Docket Number:	19-AAER-03
Project Title:	Power Factor
TN #:	232730
Document Title:	Signify North America Corporation Comments - Comments in response to IOU Technical Paper
Description:	N/A
Filer:	System
Organization:	Signify North America Corporation
Submitter Role:	Public
Submission Date:	4/13/2020 11:56:41 AM
Docketed Date:	4/13/2020

RE: Comments to Power Factor docket , 19-AAER-03

Comments to Paper on Power Factor Energy Savings Opportunities

Figure 1, 100W Incandescent Lamp Electrical Parameters

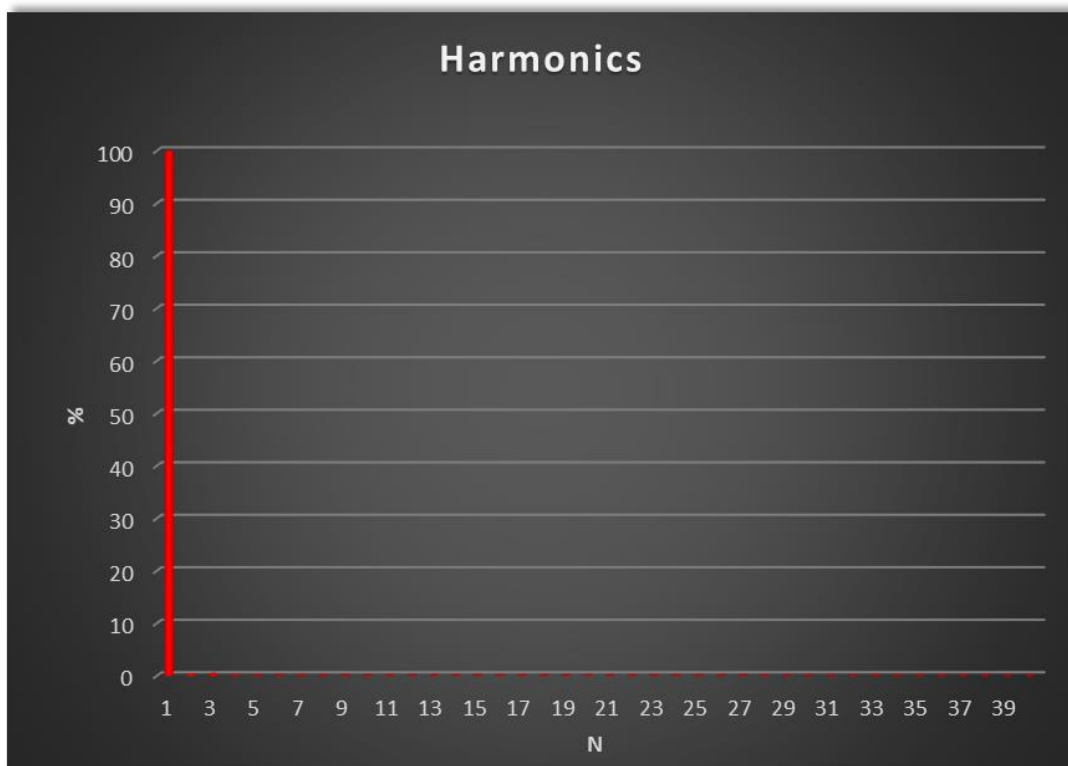
Building lighting applications have been frequently debated (Lam, 2012; Mendoza & Haring, 2018; Milardovich, Prevosto, Lara, & Milardovich, 2017). It is possible to argue that an incandescent lamp is better for the overall electrical grid because it has a power factor of one, and therefore, no harmonic distortion. Figures 1 and 2 show the electrical parameters and current harmonics of a 120V, 100W incandescent lamp.

Figure 3, 10 W LED Lamp Electrical Parameters

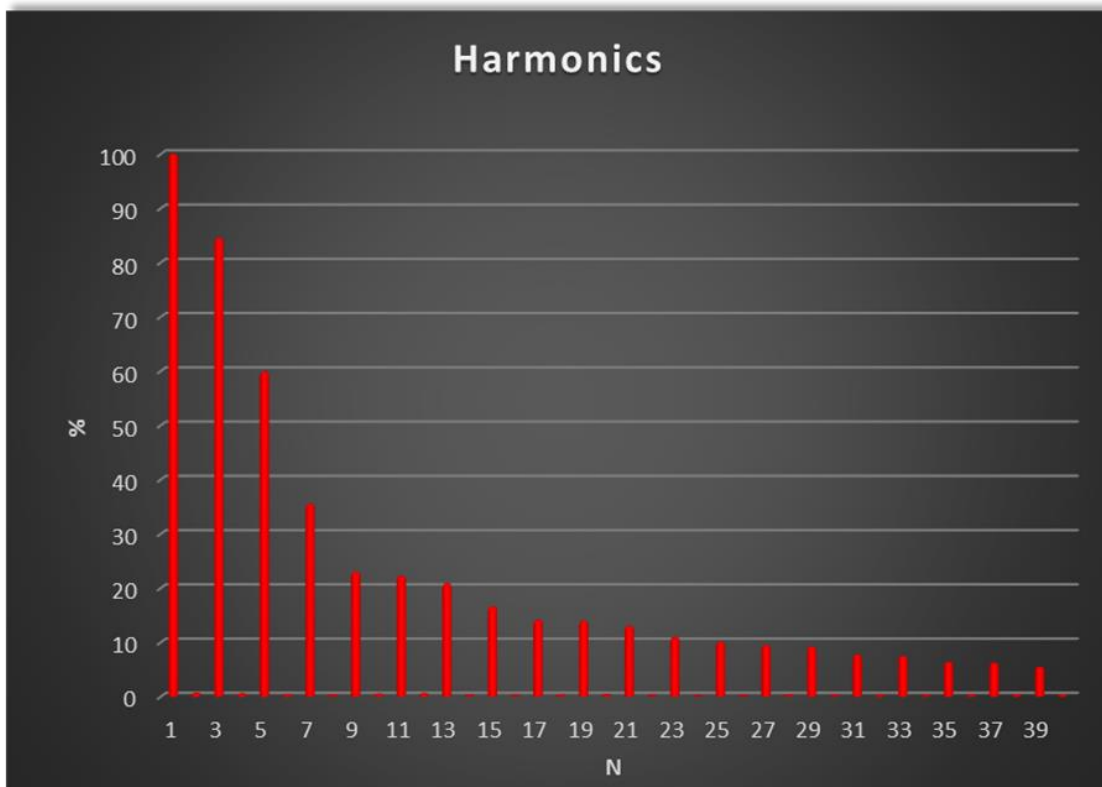
It is useful to consider how the 10 W LED lamp electrical parameters compares with the 100W incandescent lamp electrical parameters, assuming both are used to illuminate similar spaces. Figures 3, and 4.

The 10W LED lamp power factor seems to compare poorly to the incandescent lamp because; the LED lamp has a power factor of 0.57, compared to the power factor of 1 of the incandescent lamp. However, the electrical network will have reduced losses because the electrical current reduces from 0.83Arms to 0.14Arms. A load of 1 KW will be added every ten incandescent lamps, with a current consumption of 8.3Arms. Whereas ten 10 W LED lamps will be consuming 10% of the power, and they will load the circuit with a current of 1.4 Arms.

Figure 5, 100W incandescent and 10W LED Lamps Harmonic Currents Comparison %

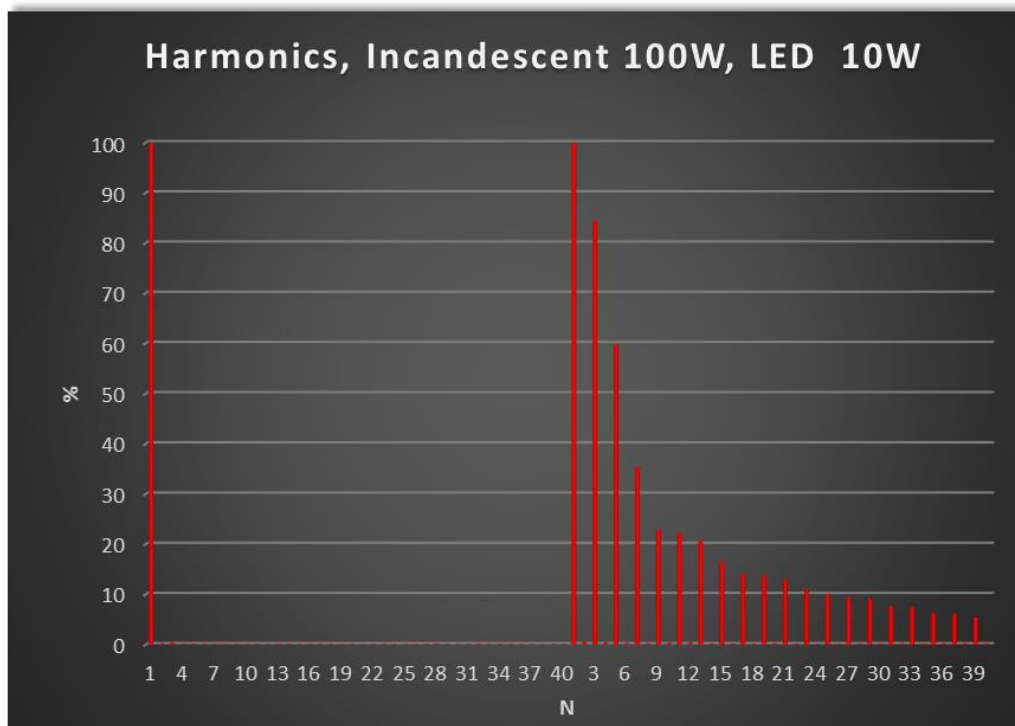
Comparing Figures 3 and 4 may lead to misunderstanding of the real power factor and harmonic distortion impact when replacing incandescent lamps by LED lamps because they are expressed in percentage. See Figures 5, and 6.

We have shown the harmonics from the incandescent lamp on the left side and the harmonics of the LED lamp on the right side in Figures 5, and 6. The harmonics comparison in RMS current (Arms) is the most useful to understand the real impact on the electrical grid for this use case. Thus, for equal illumination of similar spaces, replacing the incandescent lighting by LED lighting will result in fewer power losses in the system, regardless that the LED lamp has a lower power factor and a higher harmonic distortion. A study expanding this concept to connected IoT electrical systems, harvesting natural light, have been described in the research paper *LED Drivers Energy Efficiency and IoT* (Mendoza, Haring, & Wolfman, 2019) discussed last year at the IES annual conference.

Figure 7, Various Lamps Power Factor and Electrical Current Relationship

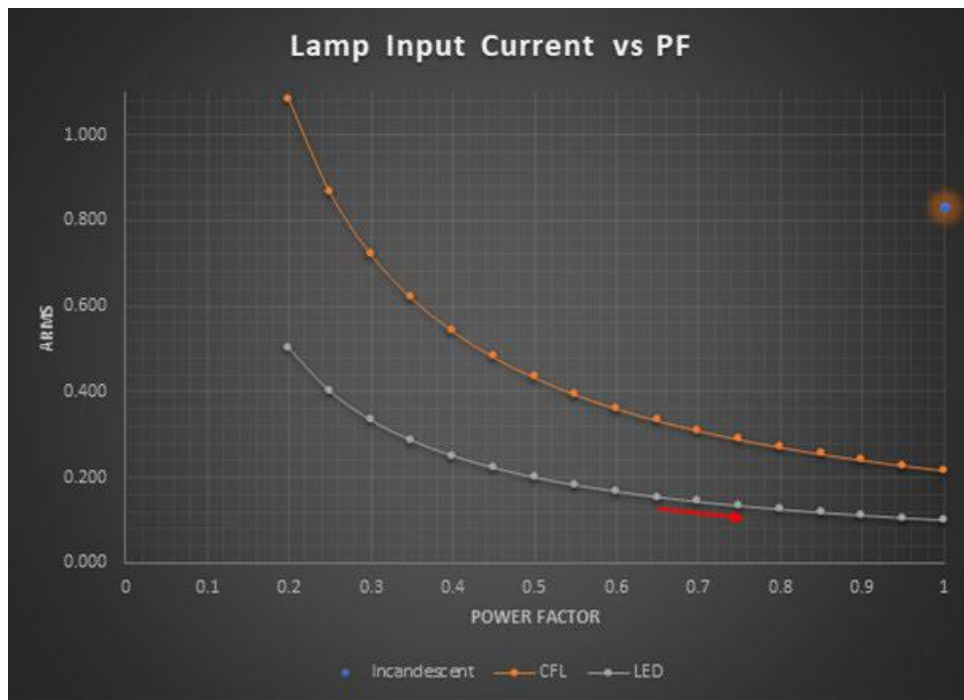
Requirements (ANSI_C822.77-10, 2020). See Figure 7. This figure describes the relationship of the power factor of an incandescent lamp, 26W CFLi lamp, and a 10W LED lamp to the electrical current expressed in RMS. The horizontal axis is the power factor, and the vertical axis is the electrical current in RMS. The blue / orange dot placed at the top right represents the 100W incandescent lamp behavior. The orange line represents the 26W CFLi, and the gray line represents the 10W LED lamp. It is worth mentioning that most LED lamps in the marketplace today have a power factor closer to 0.71 as opposed to a power factor closer to 0.5; we have used the lowest power factor in the example before to assume the worst case.

One can be tempted to ask for a LED lamp with a preconditioner or other power factor correction circuit to raise it from 0.7 to 1.00 Figure 7 depicts how there is almost no significant electrical current reduction for the LED lamp case, (follow the red arrow).
